RECEIPT DATE: 2/20/20 ONSITE SEWAGE DISPOSAL SYSTEM P 567317-A

PROPERTY ADDRESS: 16109 Ed Warfield Road

RE: OSDS Plan Review
16109 Ed Warfield Road
Woodbine, MD 21797

ONSITE SEWAGE DISPOSAL SYSTEM DESIGN PLAN

TRENCH/DRAINFIELD DATA

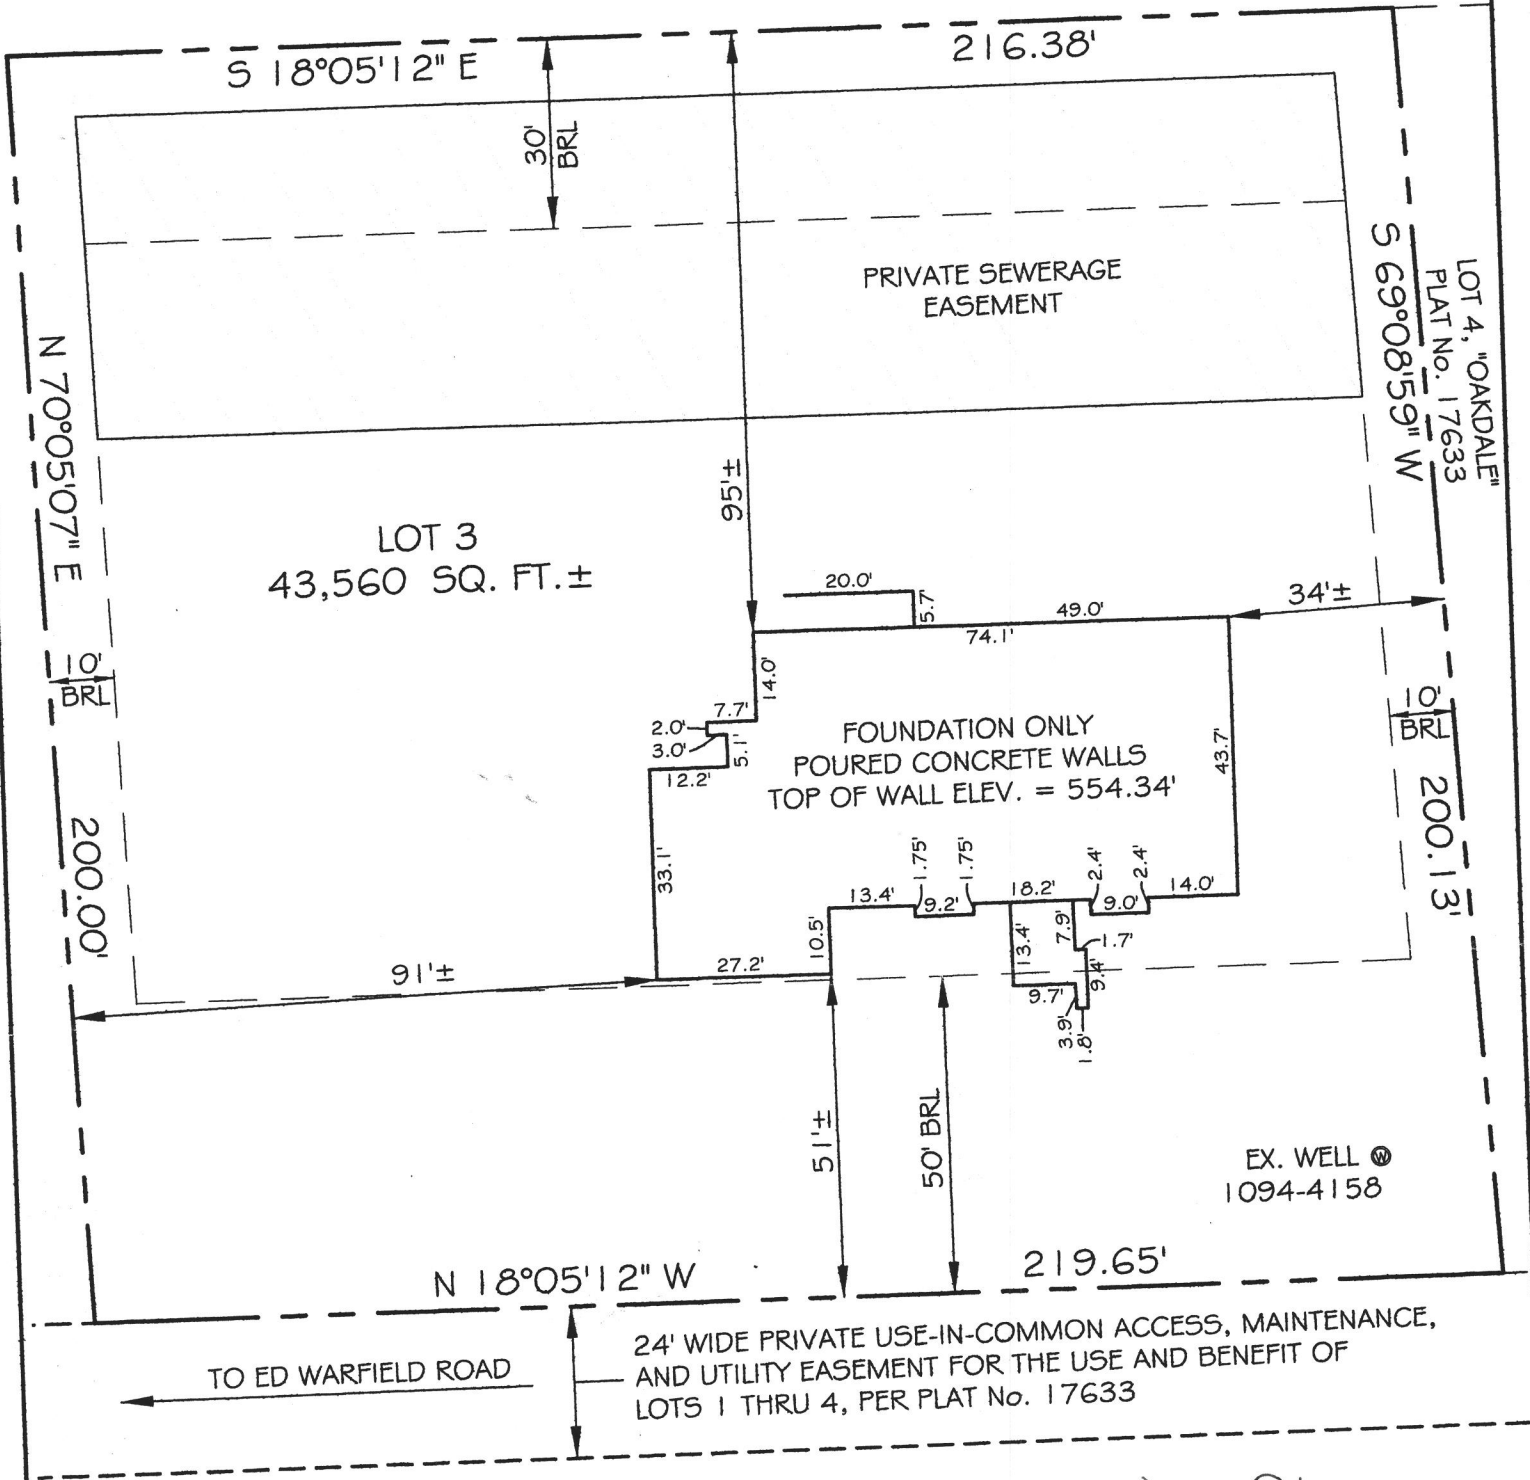
4/1/2020 No mark in basement of hung sewer location. Laid out three 52' trenches according to plan. Tank and d-box staked according to plan (ST)

INSTALLATION: 4/7/2020 Contractor set tank too close to house w/o calling in for inspection. Will have to move tank back to original location per plan. (ST)

4/8/2020 Tank re-set according to plan, 20' from house. Connected tank to d-box that had been previously cut. Reinspect for SHC. (ST) 4/9/20. Site insp. Contractor on site, SHC completed, 2 trenches completed and last trench was almost completed, 6' bottom, 3.5' of stone, stone looks good, inlet @ 2.5' trenches 13 cft, dbox level's levelers good, observation pipes at both ends of all trenches w/ the dbox obs. pipe at the front end of Trench #1, all trenches 3' wide w/ geotextile fabric in place. OK to backfill (ST)

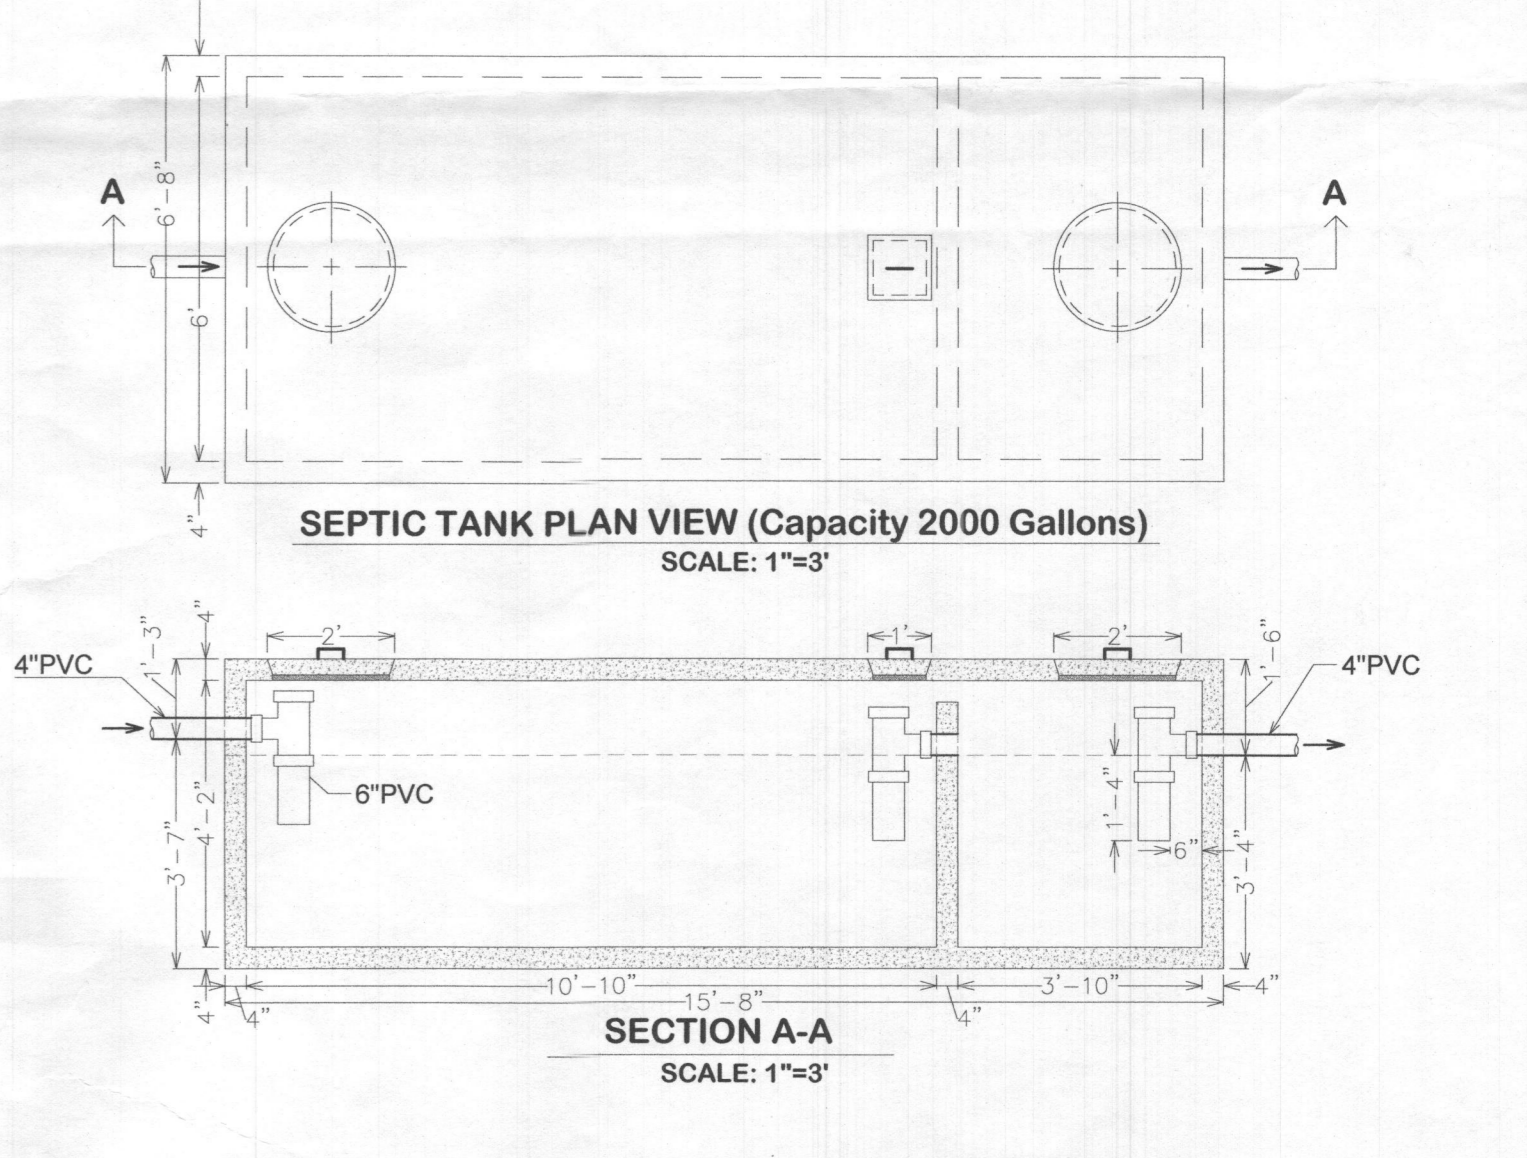
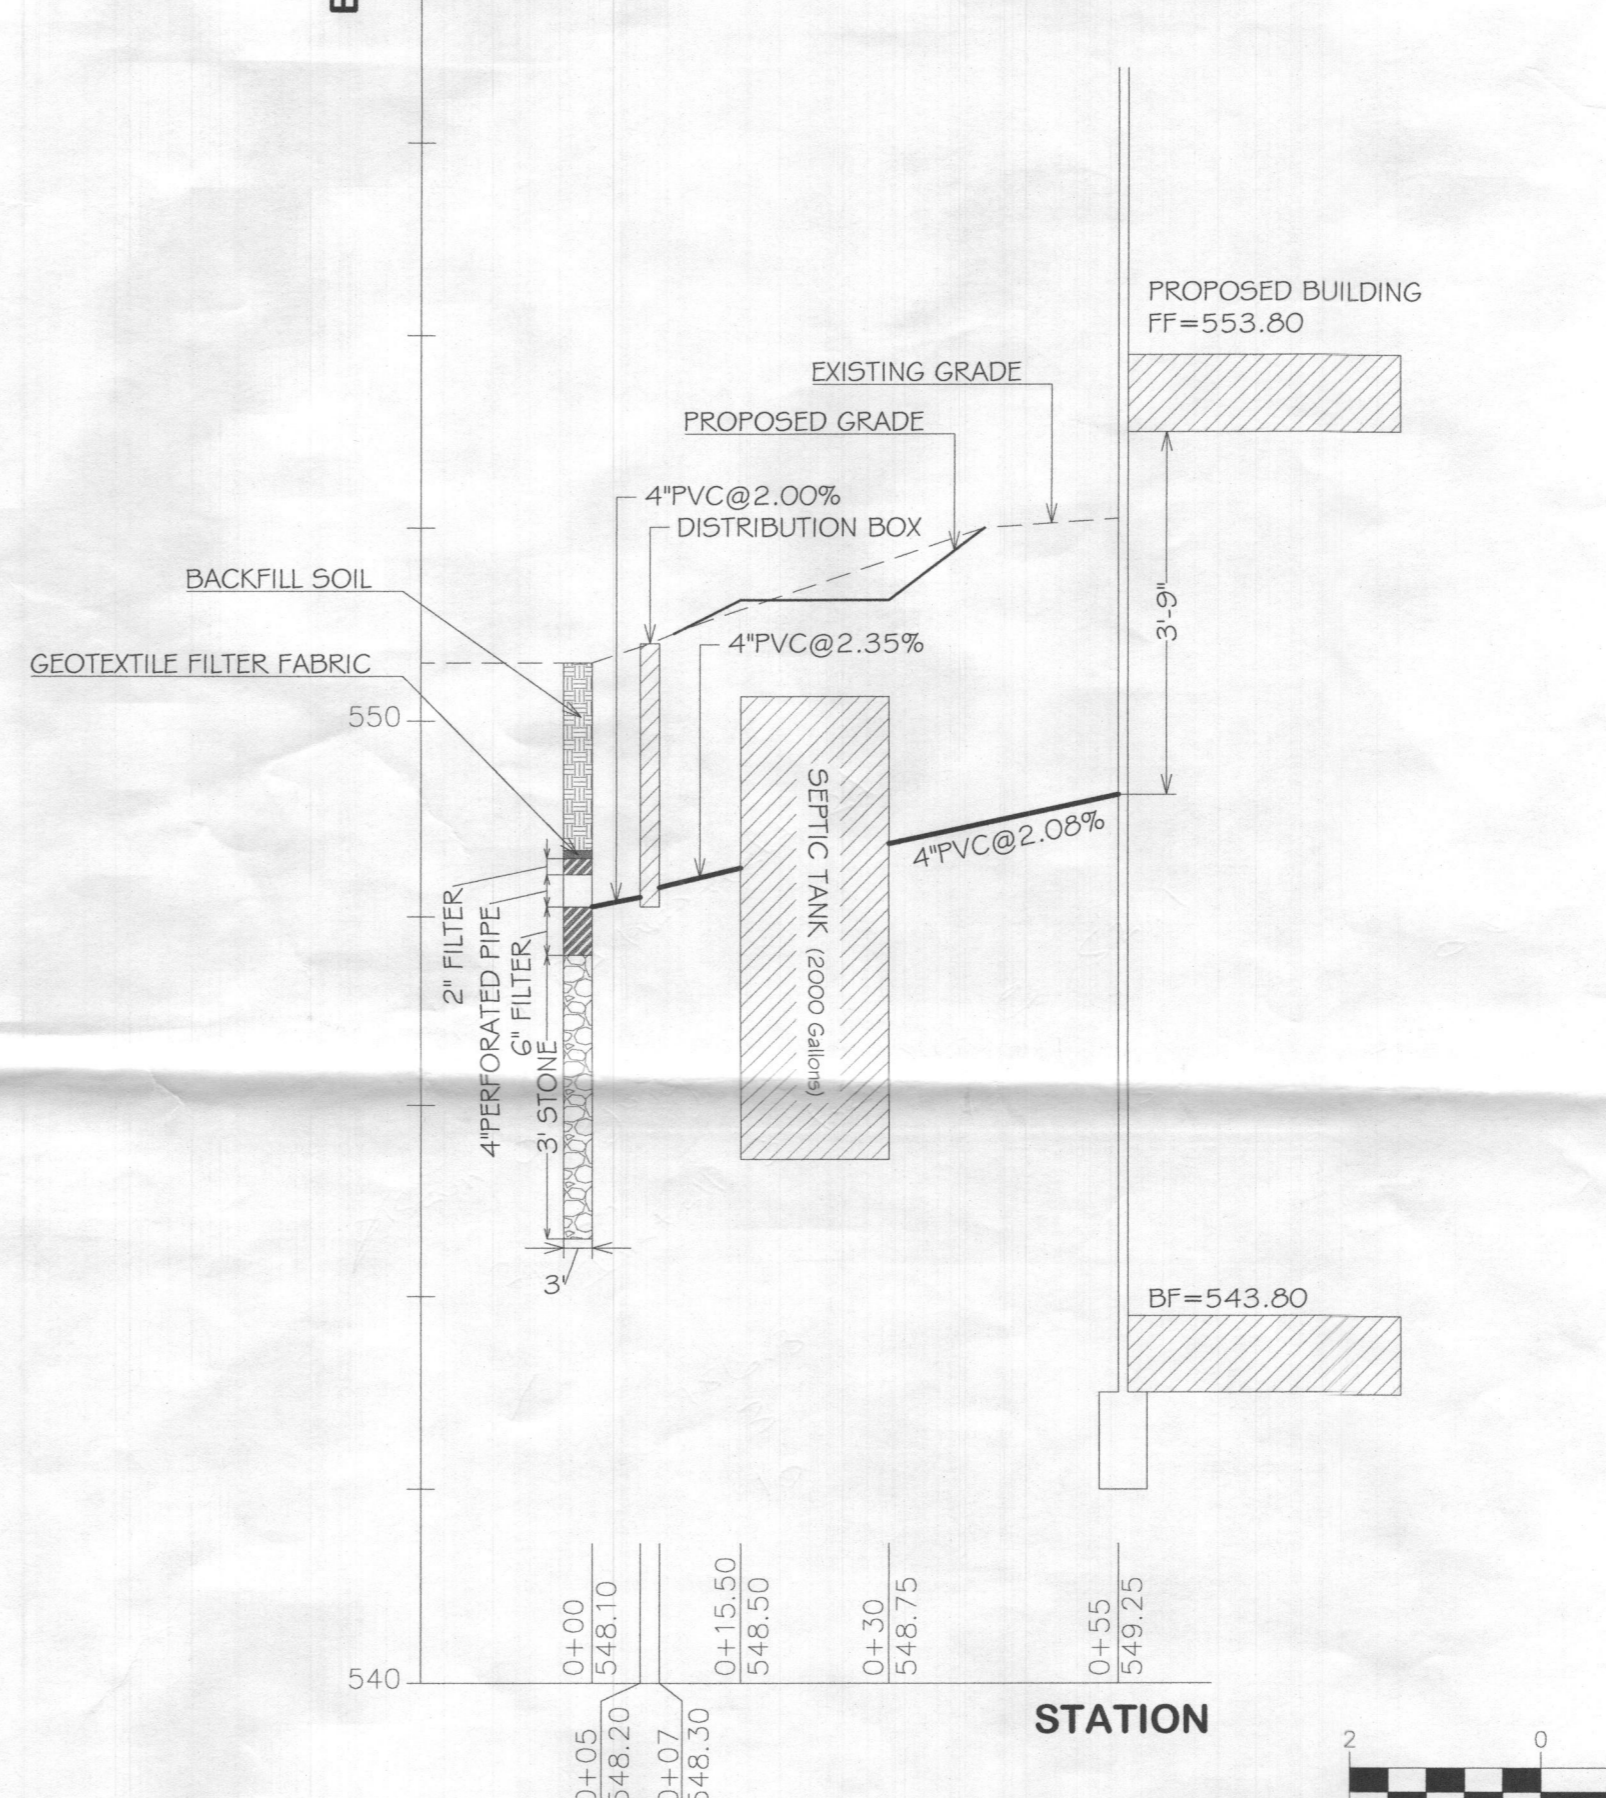
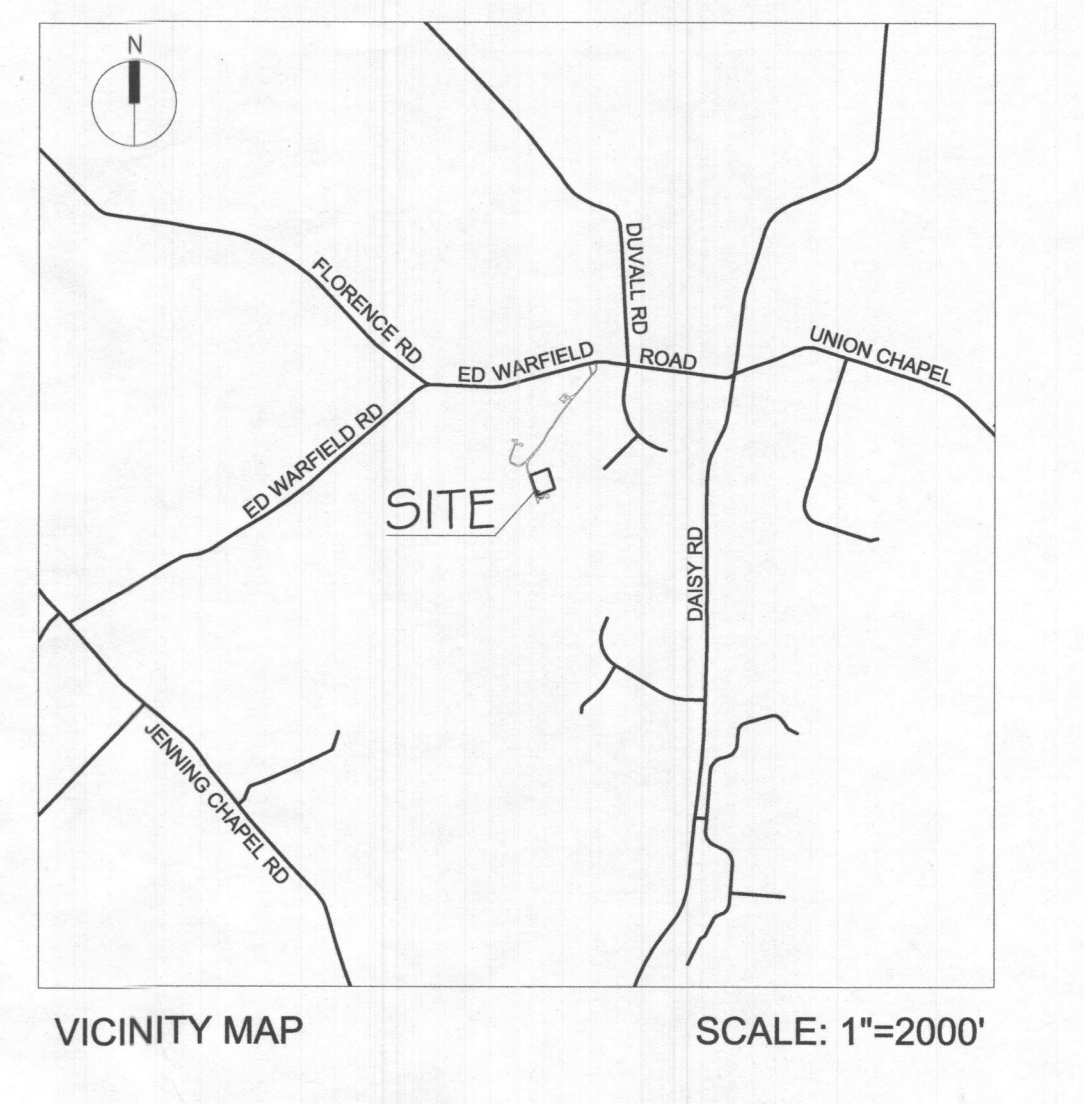
The OSDS Plan looks good but I looked over the floor plan again and the area below the balcony appears to be part of the poured foundation (see attachment). The septic tank setback to a house foundation with a basement is 20 feet. The septic tank on this plan appears to be only 11 feet from the foundation. Please correct this on the site plan and OSDS plan before submitting for final review. Also please keep in mind that the all well sites must be 30 feet from any poured foundation.

At a quick glance of this revised plan, each system still doesn't have equal length trenches. For example, the Initial system calculated with 3 foot of sidewall credit requires 156.25 feet of trench. You may design the initial system using 3 trenches at 52.1 ft. each.

Additionally, the sidewall credit calculation for the initial system has changed and is now incorrect. Per the septic specs, the initial system may not use more than 3 feet of sidewall credit (see attached septic specs).

- 1.) Each system must have equal length trenches.
- 2.) Each system must show trench width (3 feet) accurately on trench layout.
- 3.) Septic Design chart has initial system with a trench depth of only 5.5 feet. To receive full sidewall credit, change bottom depth to 6 feet (i.e. bottom trench elevation to 544.90)
- 4.) Trench separation is 10 feet (edge to edge).
- 5.) Please note: If slab below balcony is poured as part of the foundation, then the tank must meet 20-foot setback.

- x 1.) Show 1500 sq. ft. well box and well box radius on plan.
- x 2.) Add well tag # too plan. *Added A#*
- ✓ 3.) Eliminate note #3 because electrical work is not required for this installation.
- x 4.) Add note that existing well (tag #) was field located by ENGINEER/SURVEYOR on DATE. *Tag # incorrect*
- 5.) Add tank size (1500 gallon) to septic tank view.
- x 6.) Trench inverts must be between 18 in. and 4 feet in depth. (May not exceed 4 feet)
- x 7.) Trenches must be equal length unless it's an LPD design.
- x 8.) Place initial system at top of sewage disposal area (Consider using 3 trenches at 41.6 feet each and show on contour. Also, show trench width (3 feet) accurately on trench layout.
- x 9.) Septic tank must be 20 feet from house foundation with basement. *& walk up.*

10/16/19 Revised plan still requires corrections

40 scale (not 20)

NOTES:
 THE SLAB OF REAR DECK IS NOT POURED AS FOUNDATION.
